HARTZELL PROPELLER INC.
SERVICE BULLETIN
HC-SB-30-371
De-ice - Wire Harness Replacement

- (1) Hartzell Propeller Inc. has designed the 106575 wire harness to replace the affected de-ice wire harnesses used on the affected propellers.
- (a) In tests performed by Hartzell Propeller Inc., the 106575 wire harness has demonstrated greater durability than the affected de-ice wire harnesses.
- (b) The 106575 wire harness requires a different routing and additional mounting hardware for installation.
- (2) Regulatory action is not expected.

- (1) This Service Bulletin provides Instructions for Continued Airworthiness (ICA).
- (2) This Service Bulletin introduces the 106575 de-ice wire harness for use on the affected propellers.

Installing the 102691 Bolts
Figure 1

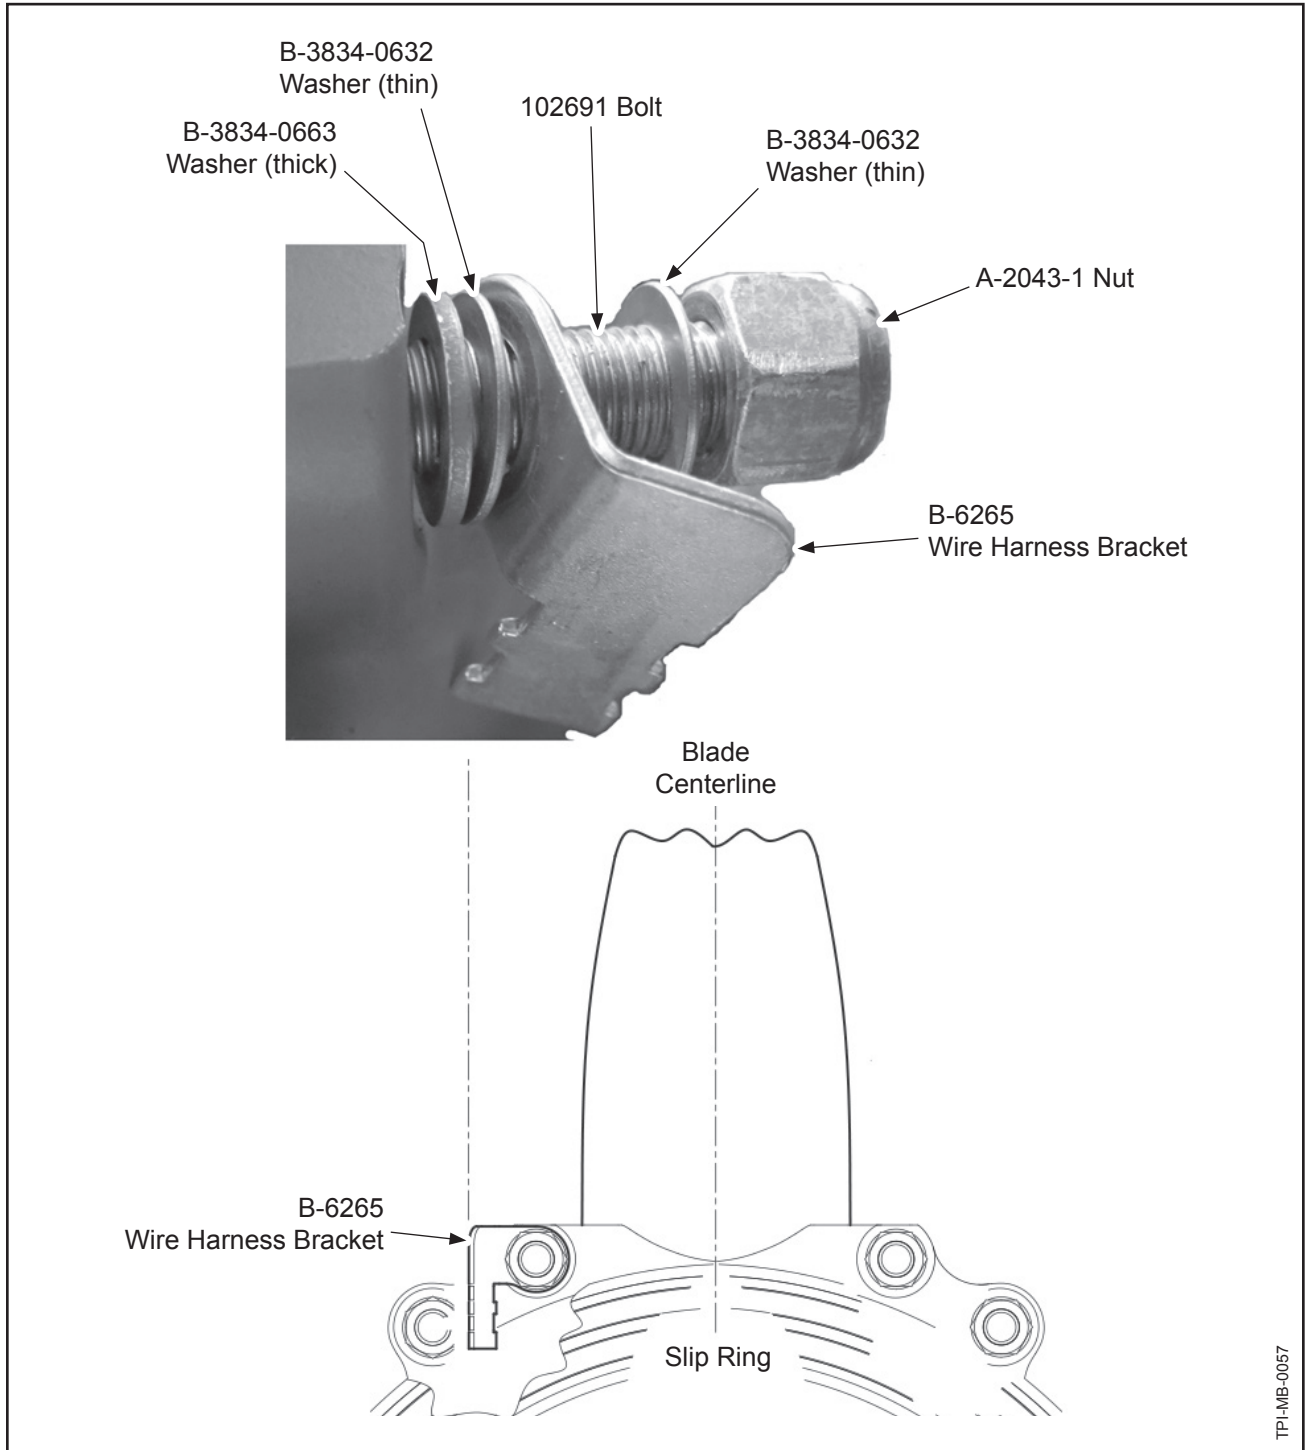
- (1) This procedure may be performed on-wing by a certified aircraft mechanic with the appropriate rating or by a certified propeller repair station with the appropriate rating.
- (2) Remove the spinner dome in accordance with Hartzell Propeller Inc. Propeller Owner's and Logbook Manual 149 (61-00-49).
- (3) Replace the hub clamping bolt on the counterweight-side of all four blades.
 - (a) Remove the A-2043-1 nut, B-3834-0632 washer, and A-2432 bolt from the hub on the counterweight-side of all four blades. Refer to Figure 1.
 - 1 Keep the four A-2043-1 nuts and B-3834-0632 washers for later use.
 - (b) Install 102691 bolts through the hub on the counterweight-side of all four blades.

Installing the B-6265 Wire Harness Bracket
Figure 2

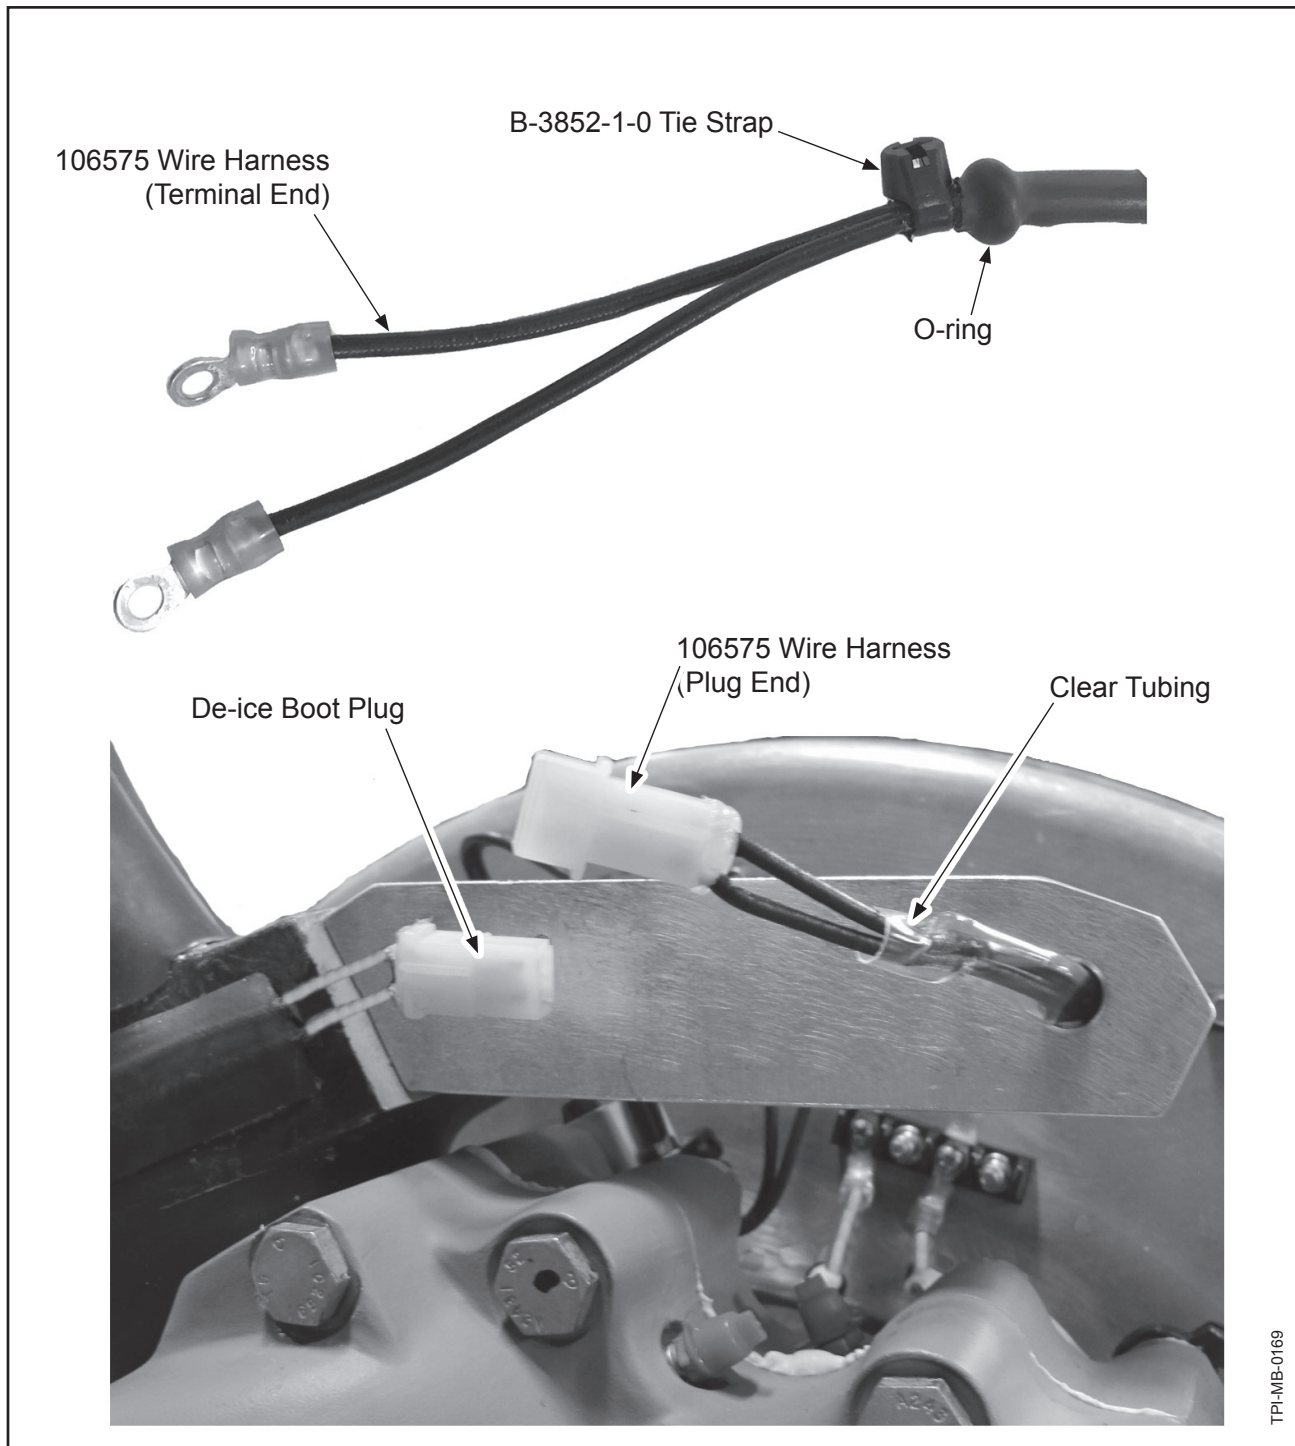
- (4) Install the B-6265 wire harness bracket as shown in Figure 2.
 - (a) Install one B-3834-0663 washer (thick), one B-3834-0632 washer (thin), one B-6265 wire harness bracket, one B-3834-0632 washer (thin), and one A-2043-1 nut onto the 102691 bolt.
 - (b) Install the B-6265 wire harness bracket so that the long edge of the bracket is parallel with the blade centerline as shown in Figure 2.
 - (c) Torque the A-2043-1 nut (dry) to 20 - 24 Ft-Lbs (28 - 32 N•m).
 - (d) Repeat step 3.A.(4)(a) through 3.A.(4)(c) for each blade.
- (5) If possible, move the propeller to low pitch using the propeller unfeathering tool TE316 or equivalent.

Routing the 106575 Wire Harness
Figure 3

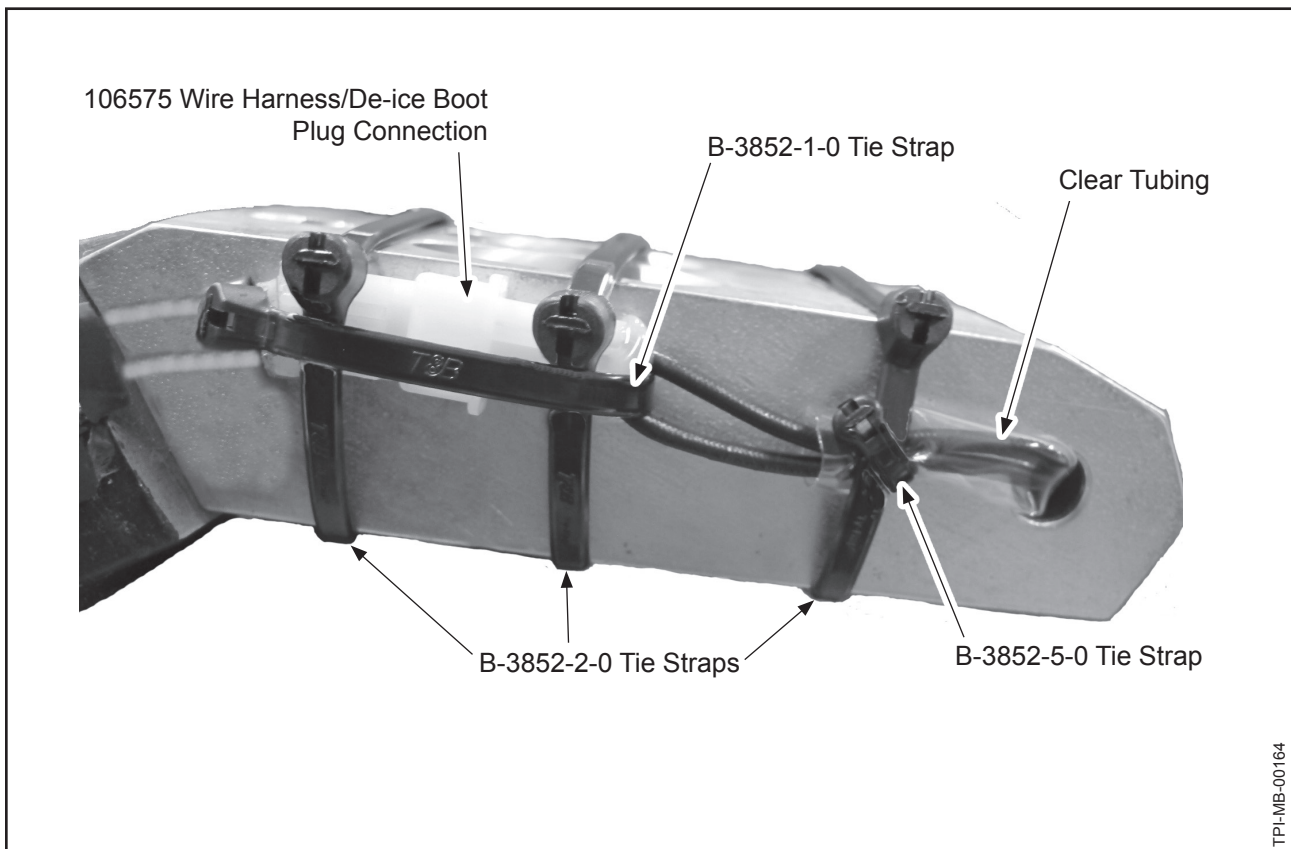
- (13) Route the 106575 wire harness.
- (a) Route the terminal-end of the 106575 wire harness through the hole in the counterweight as shown in Figure 3.
- 1 Move the 106575 wire harness so that equal lengths of the clear tubing are on each side of the counterweight.
- (14) Install one B-3852-1-0 tie strap around the 106575 wire harness below the O-ring at the terminal-end of the harness as shown in Figure 3.
- (15) Assemble the plug connection between the 106575 wire harness and the de-ice boot.
- (a) Install one B-3852-1-0 tie strap around the wire harness/de-ice boot plug connection as shown in Figure 4. Do not tighten the tie strap.

106575 Wire Harness/De-ice Boot Plug Connection
Figure 4

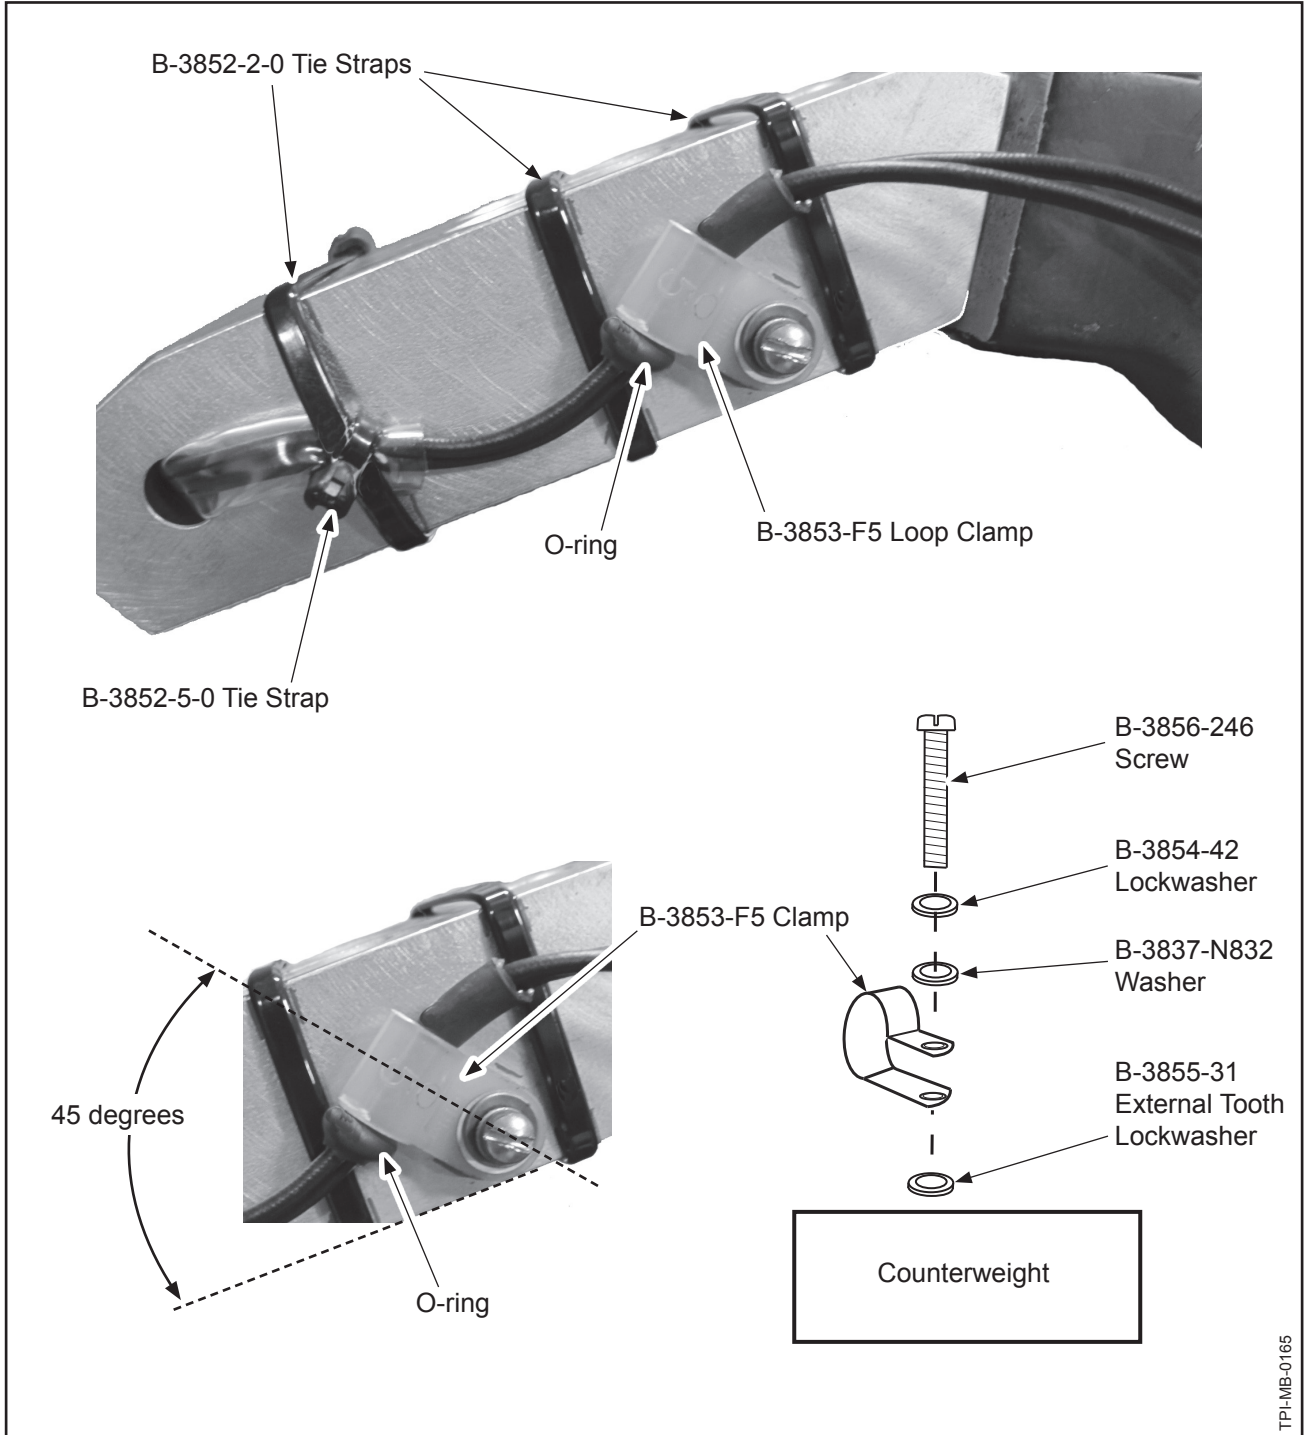
- (c) Torque the B-3856-246 screw to 15-18 In-Lbs (1.6-2.0 N•m).
- (17) Attach the 106575 wire harness/de-ice boot connection to the counterweight.
- (a) Install two B-3852-2-0 tie straps under the B-3852-1-0 tie strap holding the plug connection, and around the counterweight/wire harness as shown in Figure 4 and Figure 5. Do not tighten the tie straps.

- 1 Position the heads of the two B-3852-2-0 tie straps as shown in Figure 4.
 - (b) Install one B-3852-2-0 tie strap around the counterweight, and over the clear tubing on the 106575 wire harness as shown in Figure 4 and Figure 5. Do not tighten the tie strap.

- 1 Make sure the B-3852-2-0 tie strap is over the clear tubing of the 106575 wire harness on both sides of the counterweight.
 - 2 Install one B-3852-5-0 tie strap around the clear tubing on the 106575 wire harness and the B-3852-2-0 tie strap on both sides of the counterweight as shown in Figure 4 and Figure 5.
Do not tighten the tie strap.

106575 Wire Harness Routing
Figure 5

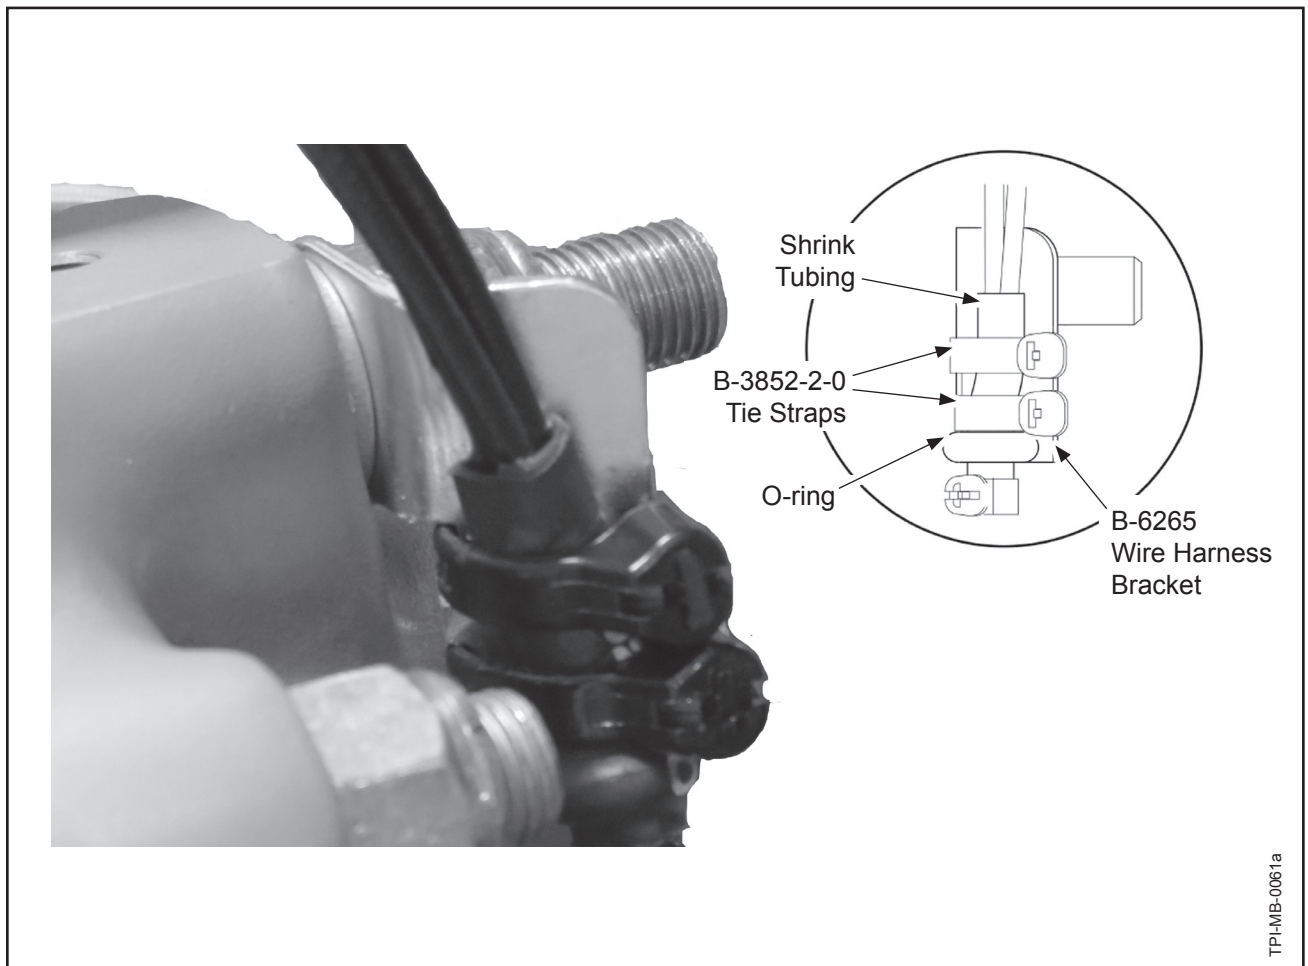
- (16) Install the B-3853-F5 clamp around the 106575 wire harness with the O-ring positioned against the clamp as shown in Figure 5.
- (a) Apply threadlocking adhesive CM116 to the threads of the B-3856-246 screw.

- (b) Using the B-3856-246 screw, B-3854-42 lockwasher, B-3837-N832 washer, and B-3855-31 external tooth lockwasher install the B-3853-F5 clamp to the counterweight in accordance with Figure 5.

Securing the 106575 Wire Harness to the B-6265 Wire Harness Bracket
Figure 6

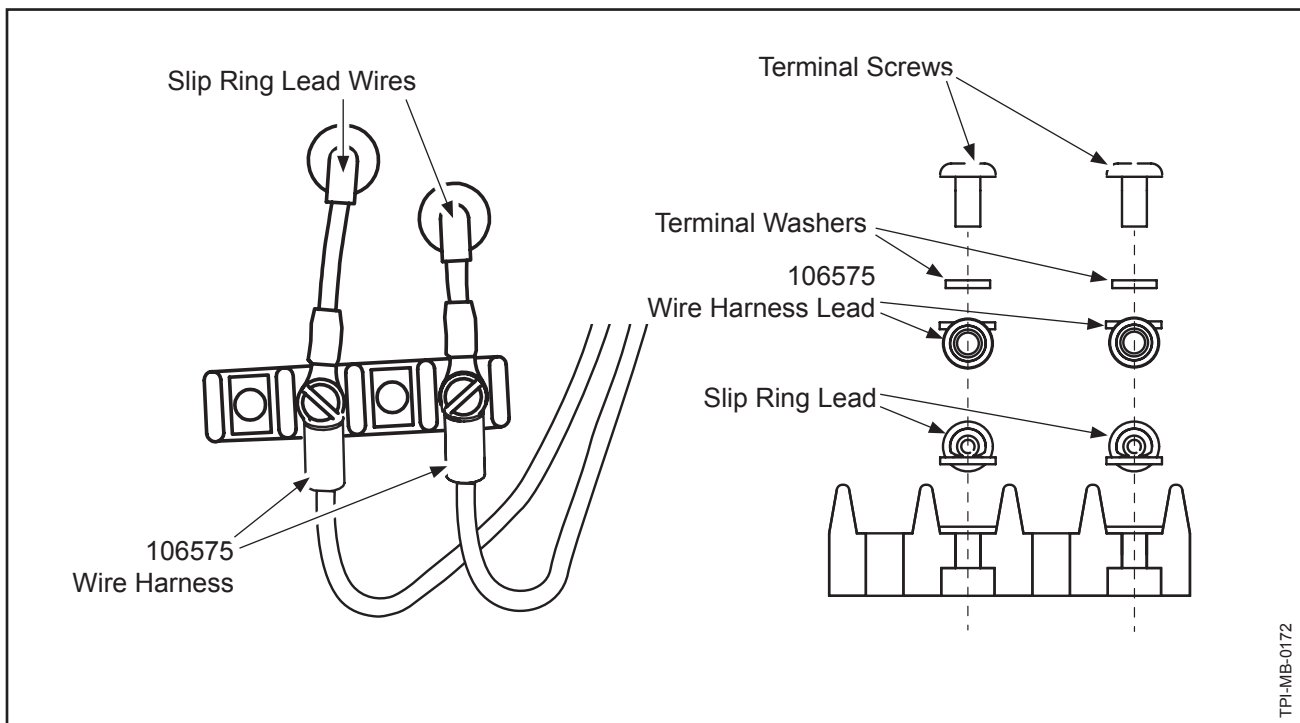
- (19) Attach the 106575 wire harness to the B-6265 wire harness bracket.
- (a) Put the O-ring/shrink tubing on the terminal end of the 106575 wire harness so that the O-ring is at the bottom of the B-6265 wire harness bracket as shown in Figure 6.
- 1 Make sure the lead wires are not twisted or bent sharply.
- (b) Install and tighten two B-3852-2-0 tie straps around the bracket and the shrink tubing on the wire harness as shown in Figure 6.
- 1 Put the tie straps in the grooves on the wire harness bracket.
- 2 Put the heads of the tie straps as shown in Figure 6.
